MetroLink

Transport Infrastructure Ireland

EIAR Addendum: Leinster Street Pumping Station

| P01.1

Figure 3.1: Horizontal Alignment Showing Proposed Pumping Station

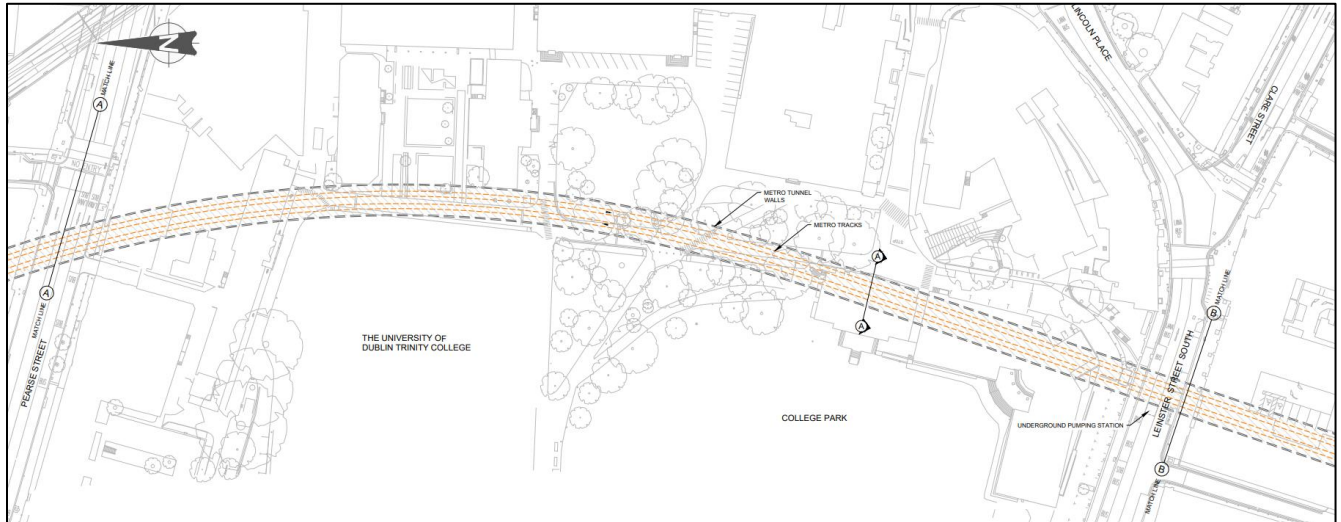
As there is a low point in the tunnel along this section of the alignment at Chainage (Ch.) 17+947, a pumping station is required to facilitate drainage at this location. As a result, a pumping station is proposed at Ch.17+947. This location has been chosen to locate the pumping station away from any buildings under Leinster Street South. This is to minimize potential construction settlement and noise impacts on properties. Figure 3.1 below outlines the location of the pumping station.
